TERENCE
O'ROURKE

Application reference: WSCC/011/21

Ford Circular Technology Park

FORD ERF AND WSTF

FORD ROAD/ ACCESS ROAD
VEHICLE TRACKING
(ARTICULATED TRUCK - 16.5m)

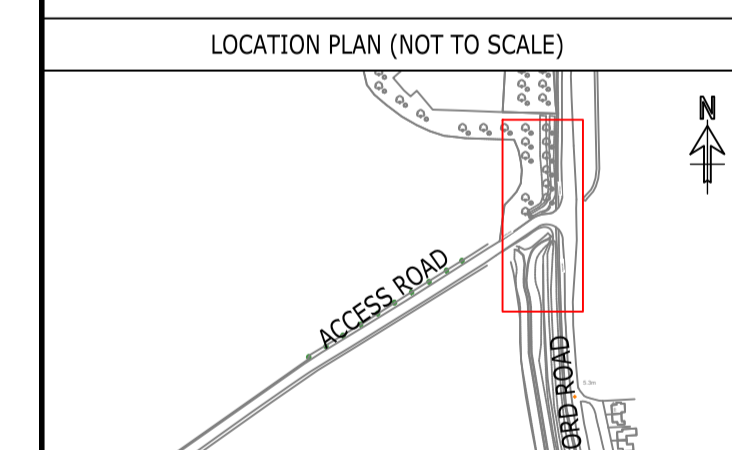
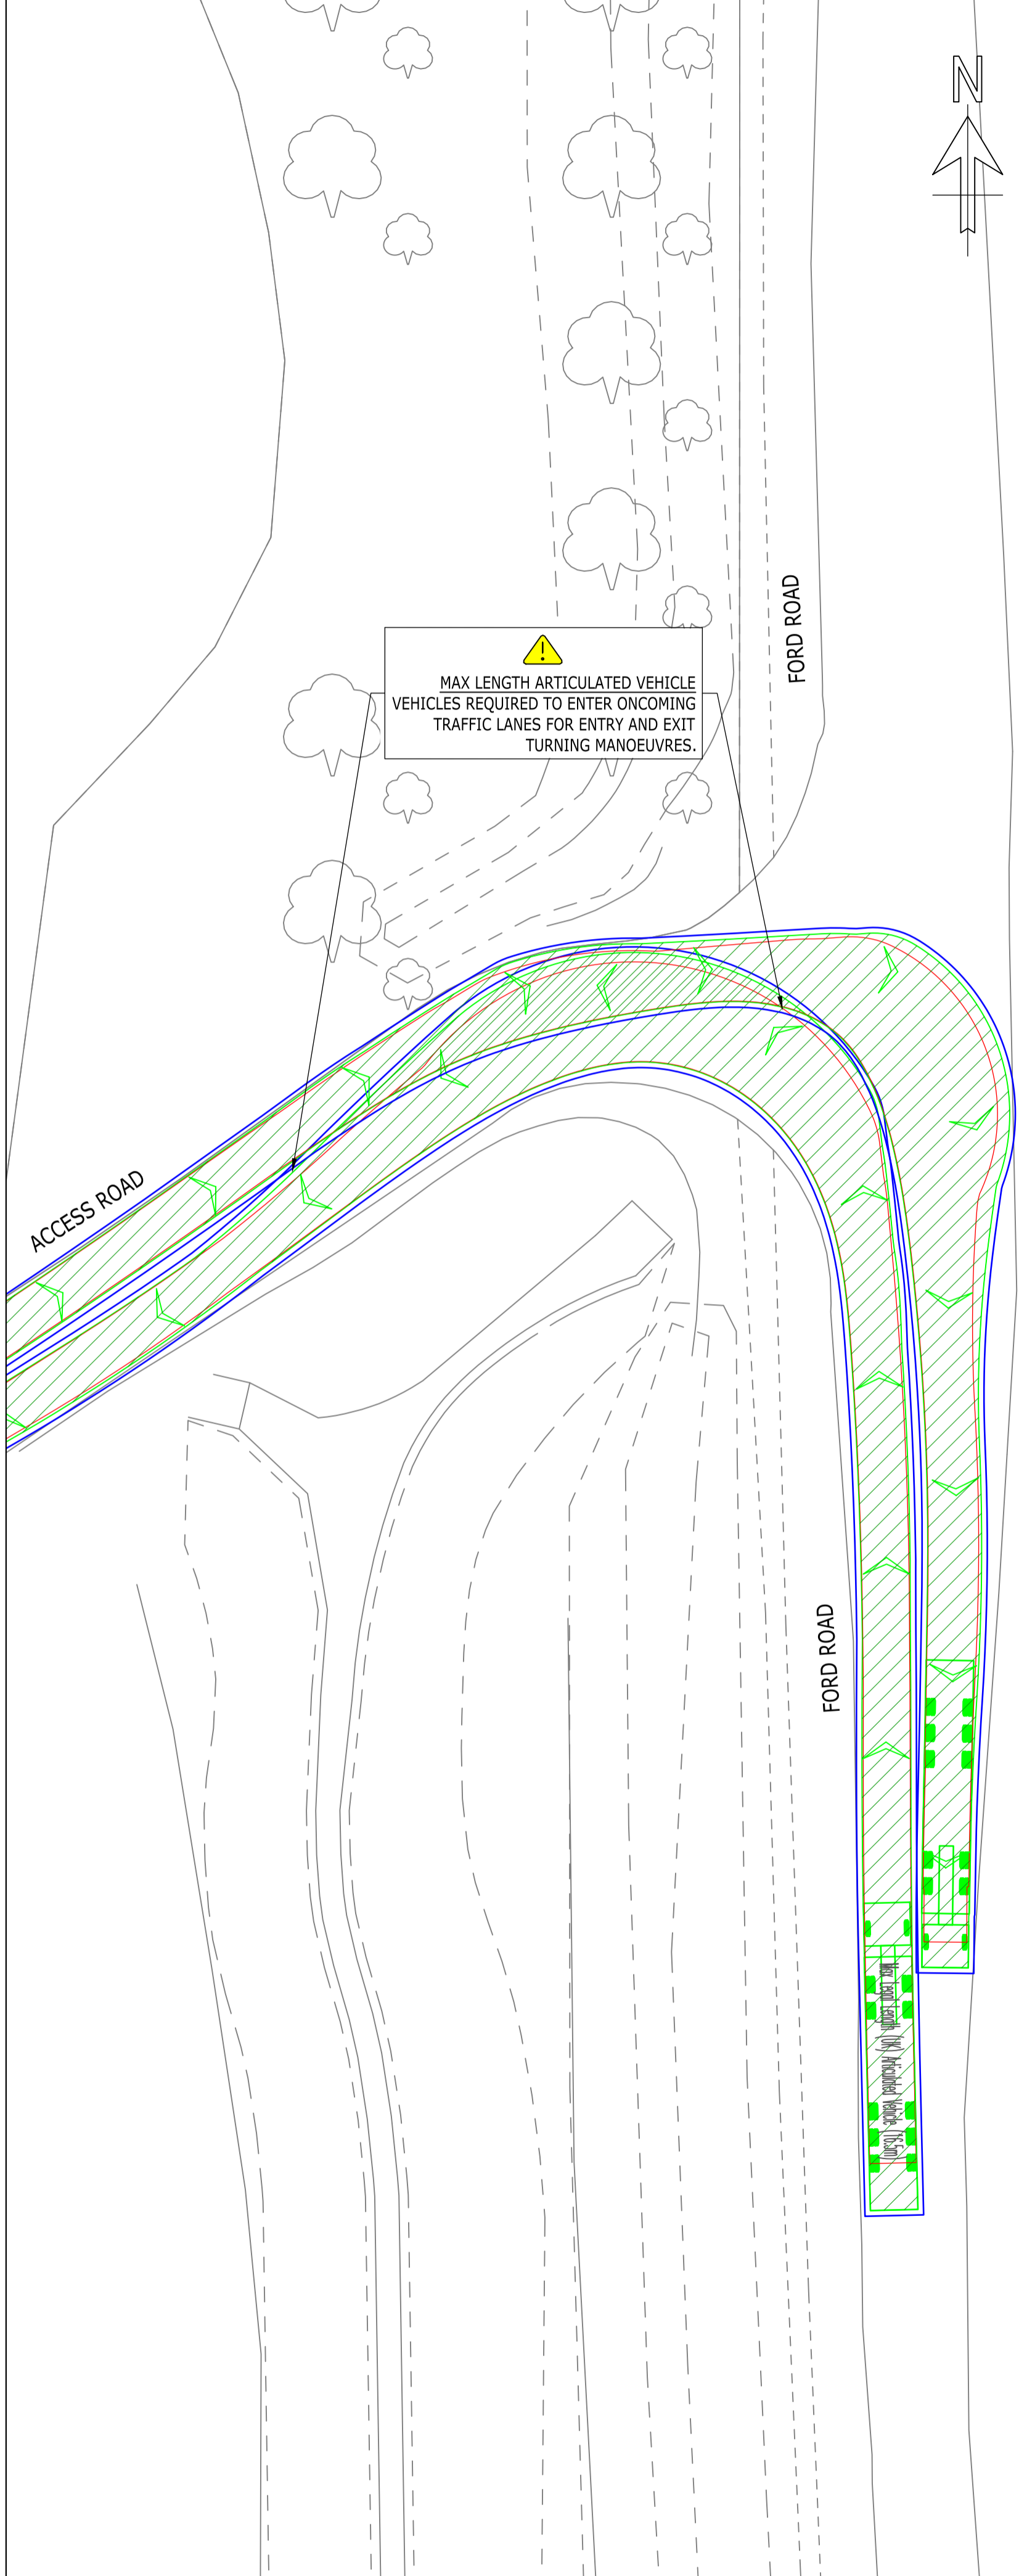
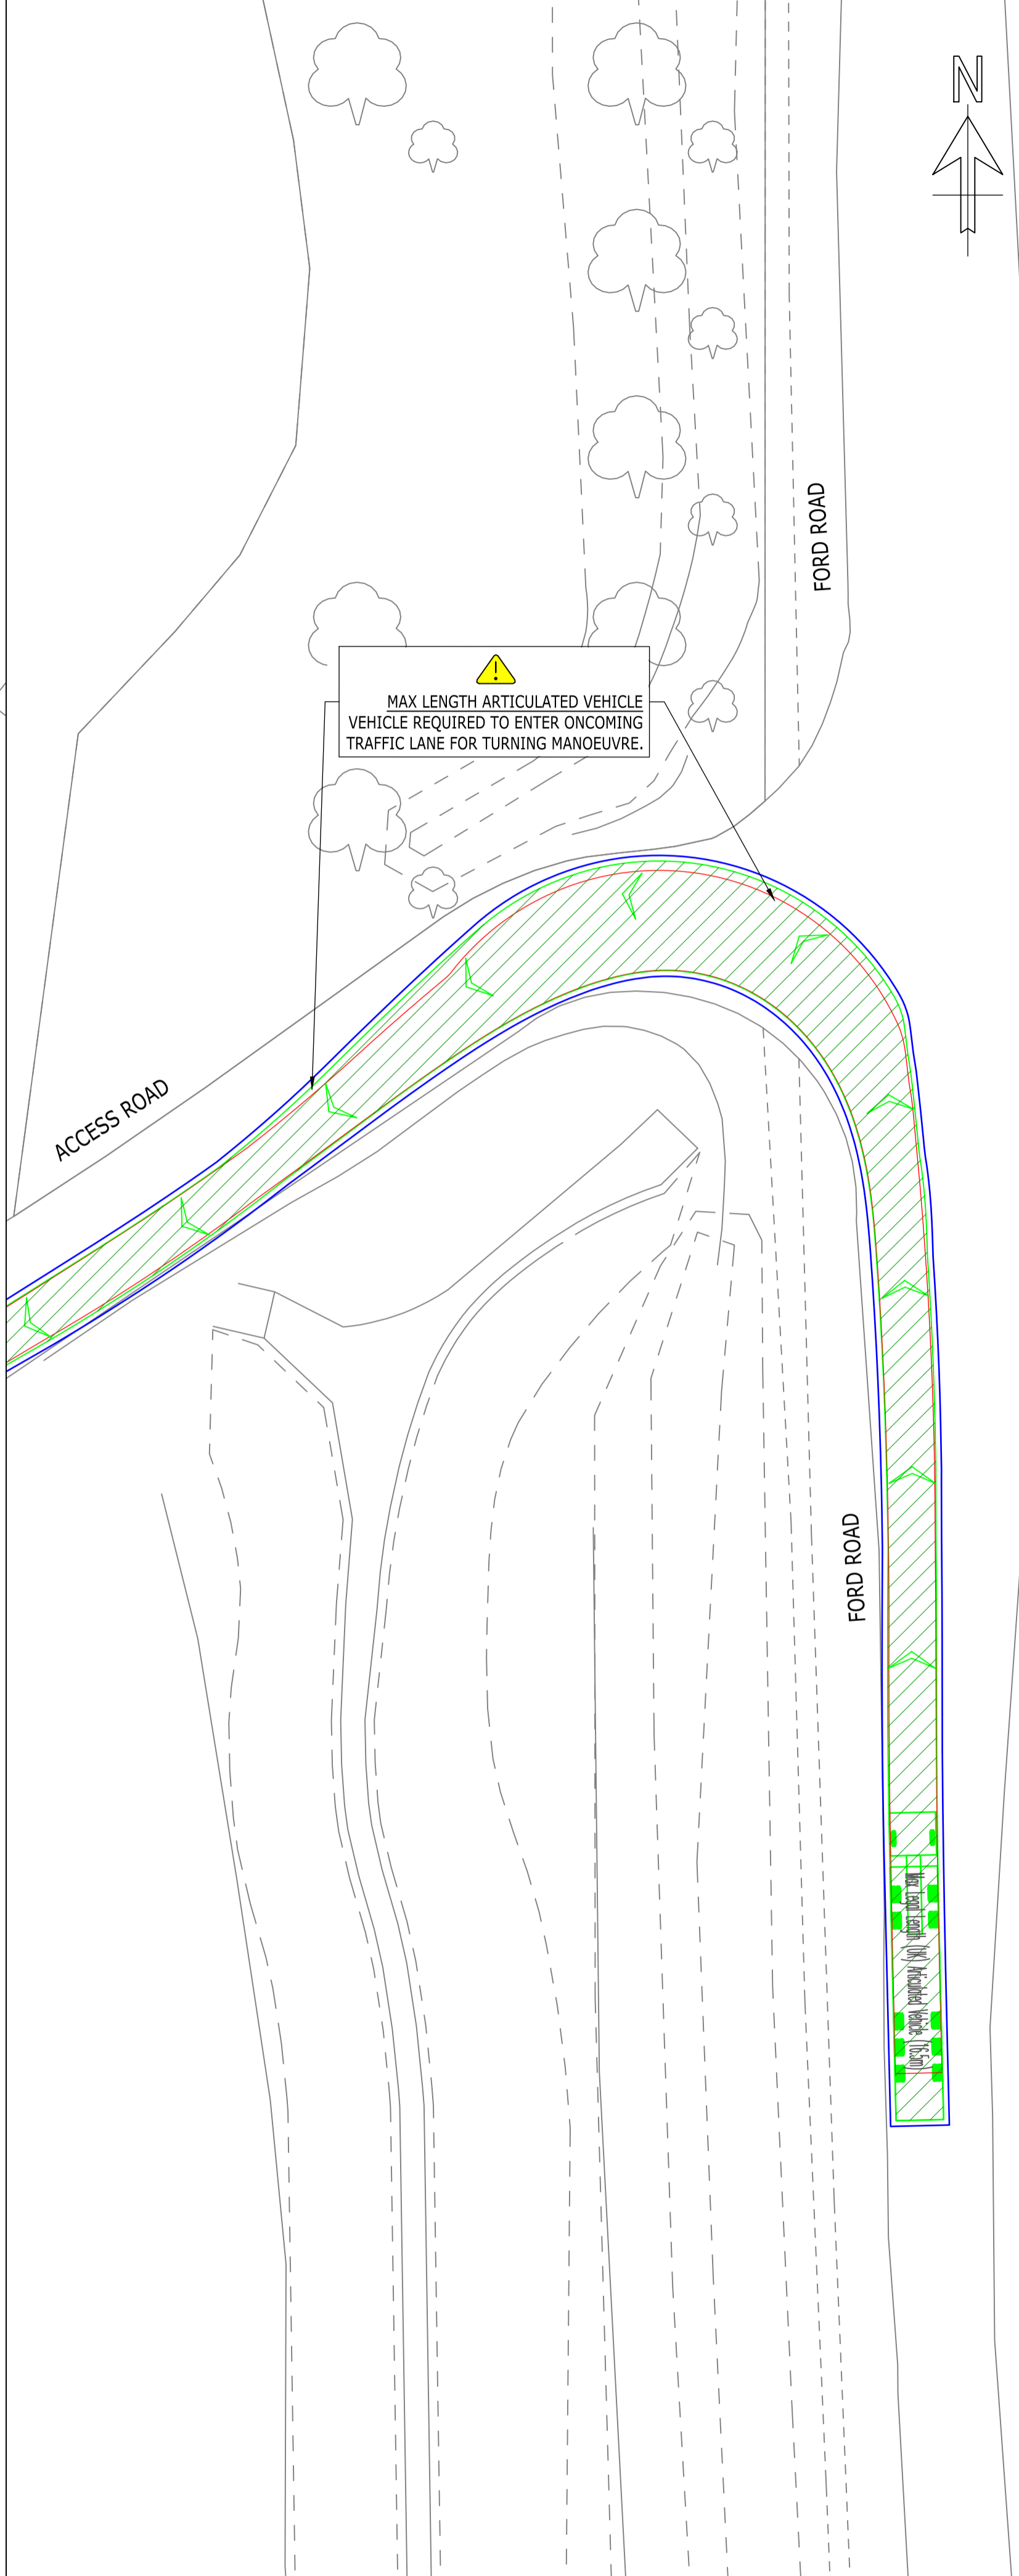
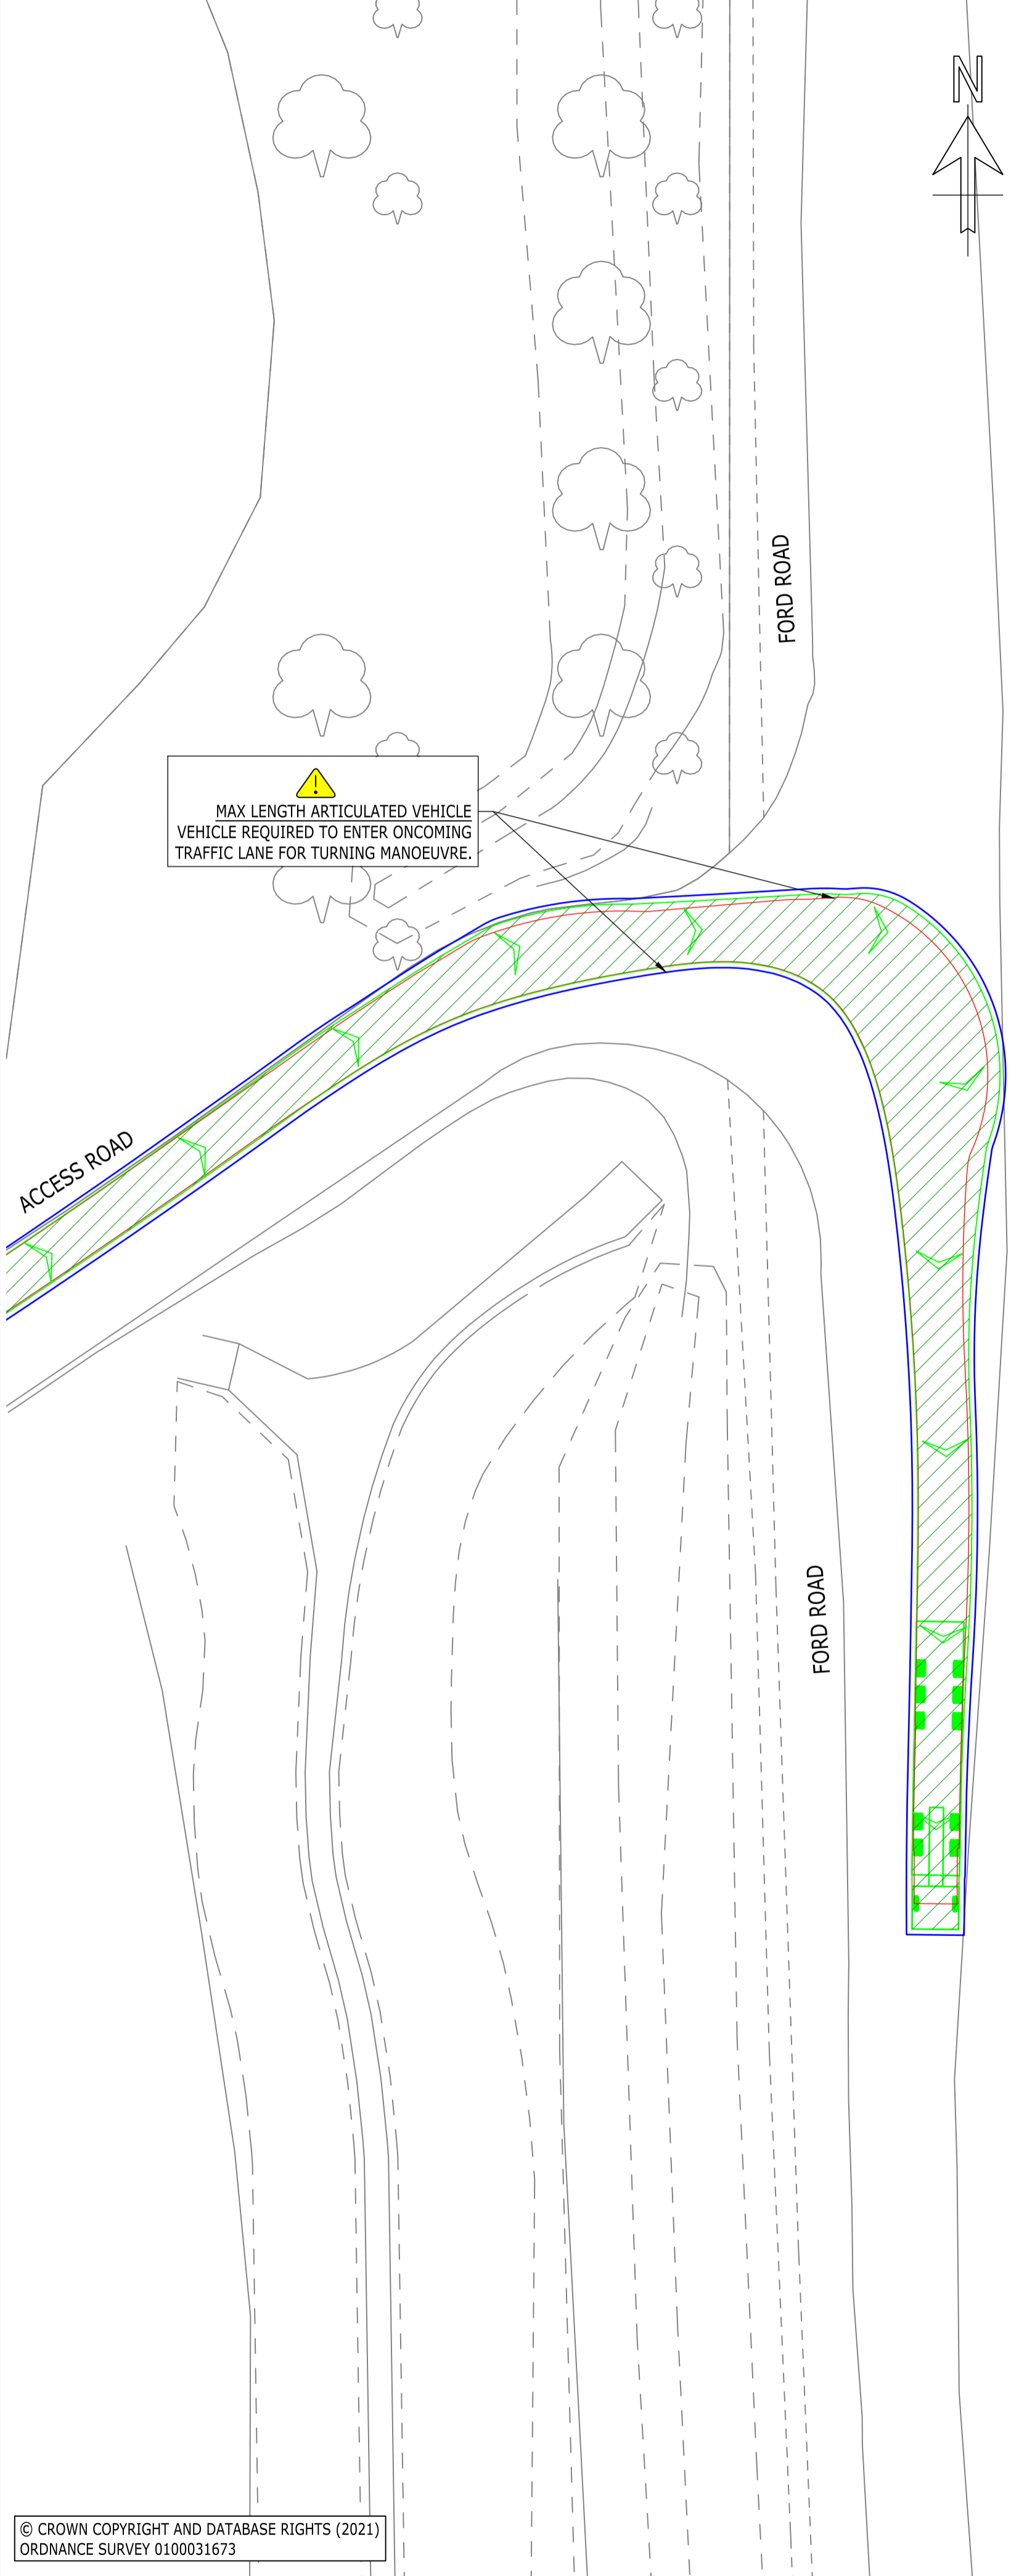
The tracking shows two-way 44T 6 axle HGVs do potentially clash on the turn owing to the width at the neck of the access road, in circumstances where both inbound and outbound vehicles arrive at the junction together.

However, these types of HGVs frequently use the access today and there is no record that any accidents have occurred. This is why the applicants' Designers' Response disagrees that there is a problem and therefore also disagrees that there is a resulting need to modify the existing access road junction.

Given that two-way HGV movements of this type happen today and no accidents are recorded, it is considered that, in practice, HGV drivers effectively manage any conflict themselves, should this occur.

not cause any changes to the vehicle types that use the junction. The operation of the current junction today with movements of HGVs in and out indicates that there are no real practical difficulties for HGV drivers using the junction. This does not indicate a need for any changes to the junction to address the tracking results.
